**Re: Floor Flatness Test Results**

**Construct Building 405 for 75 MH RRTP Beds, VA Project #676-322** AE Project # 13316

Re: **Floor Flatness Test Results**  
**Tomah VA – Building 405**  
**Tomah, Wisconsin**  
**CVT Project# 6383.14.WIL**

Pour 8/6/15

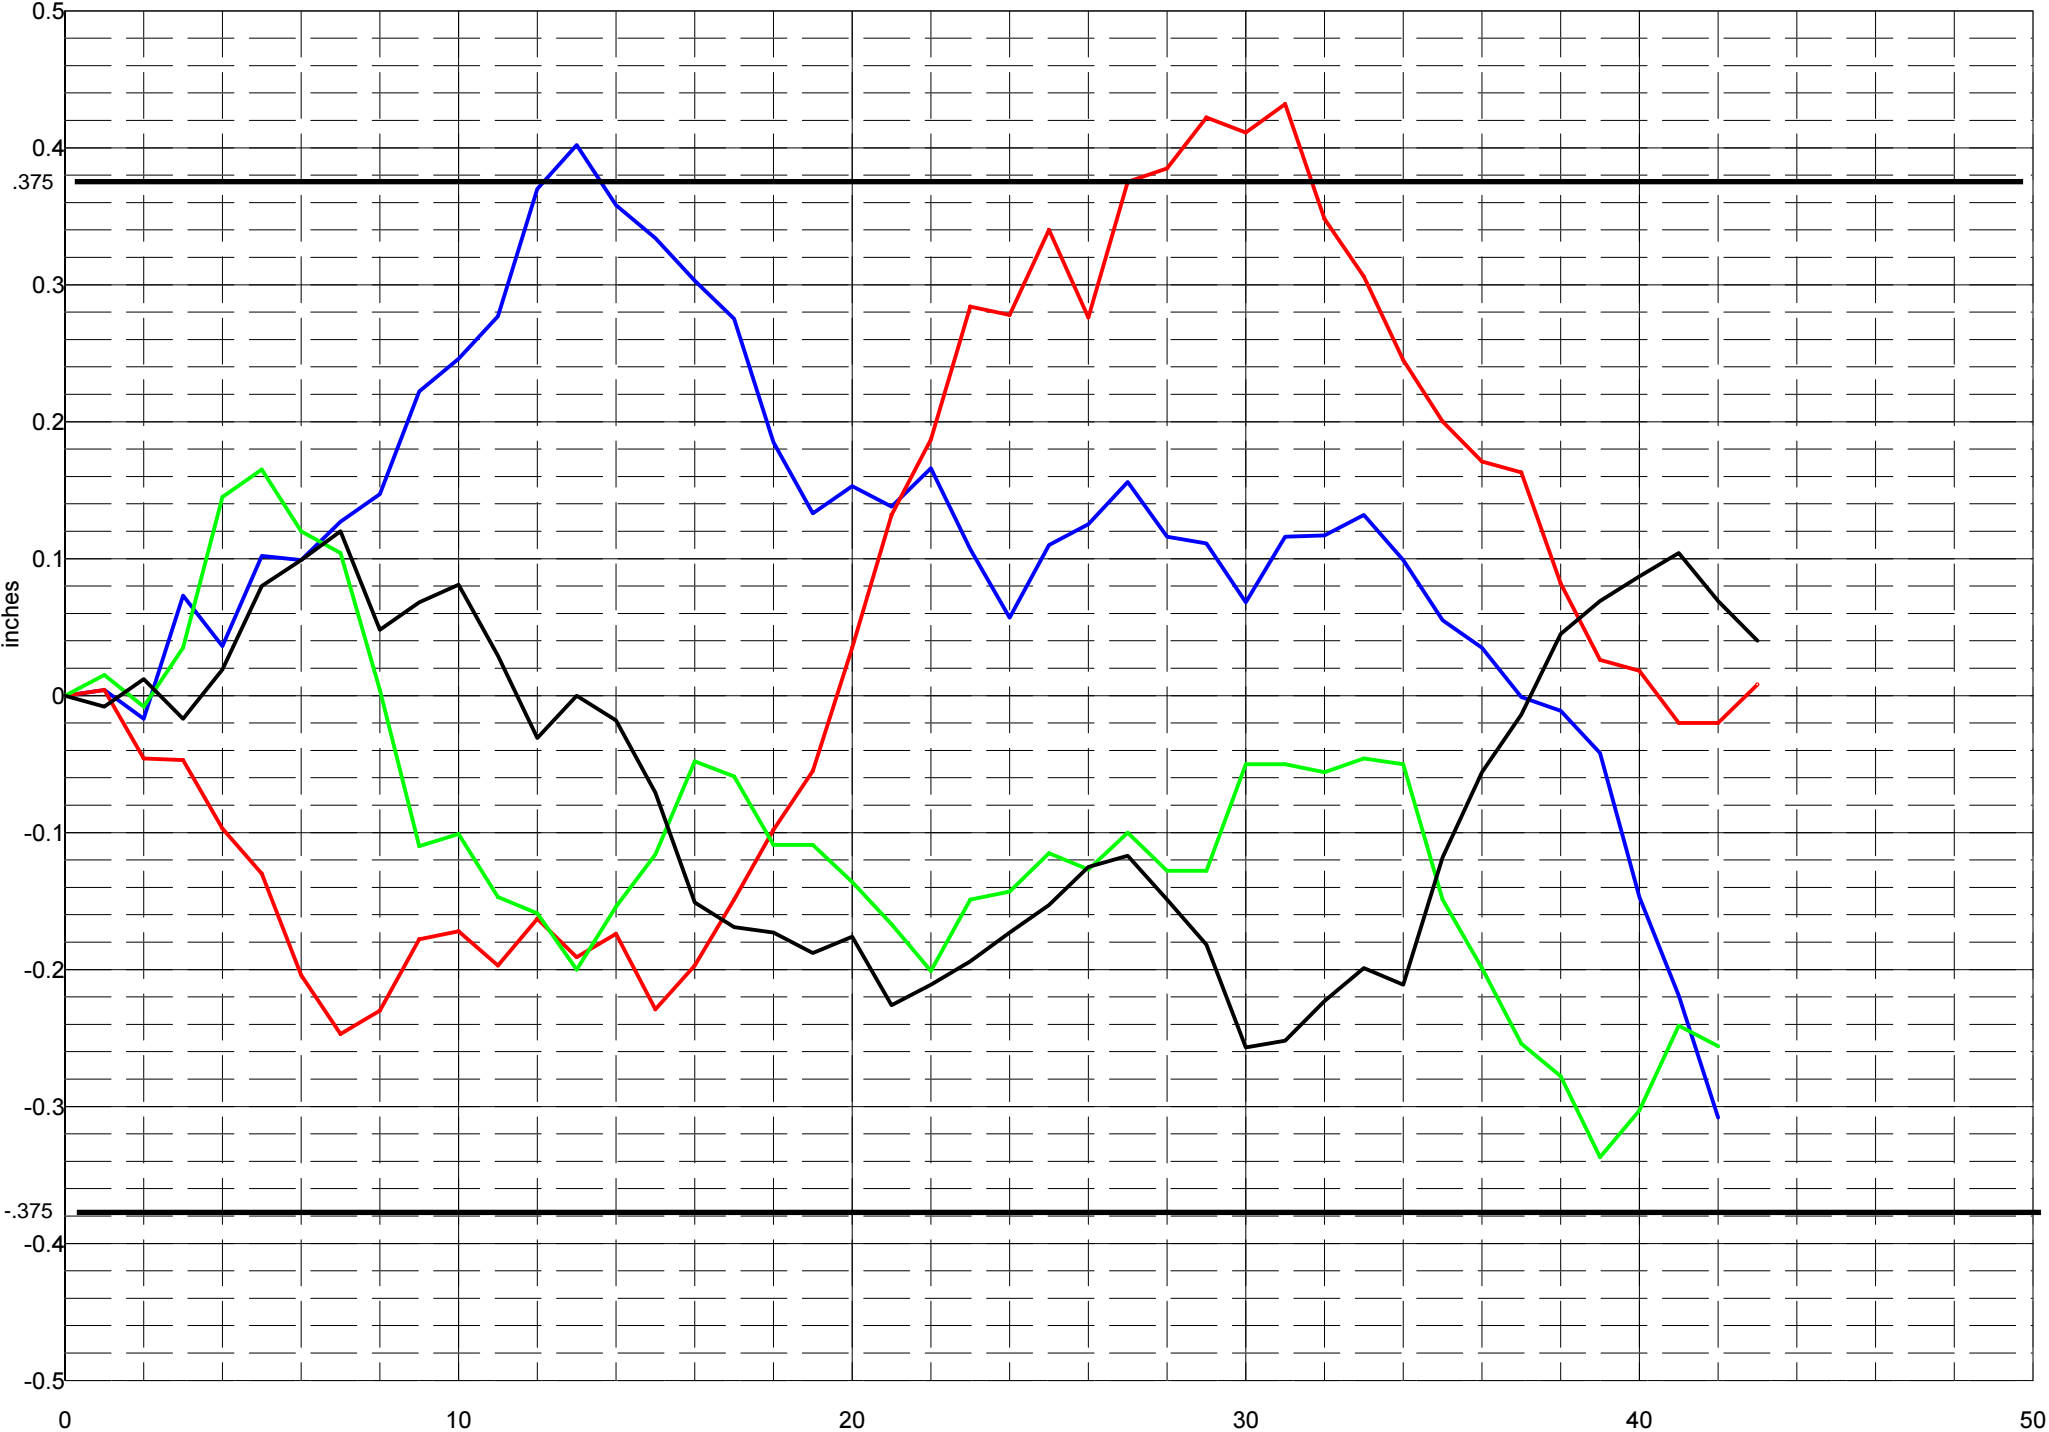
- 1) The combined FF of the slab on grade for the main building pour areas is 27.11, and the combined FL is 19.75. Both of these are lower than the specified overall values of 36 and 20, respectively, and require remedial measures to bring the slab within specified tolerances. Remedial measures to correct the slab areas are detailed in the project specifications and include grinding, planing, surface repair with underlayment compound or repair topping, re-topping, or removal and replacement of entire rejected slab areas. We recommend that a corrective plan of action be submitted by SEEDJV for approval by the VA.
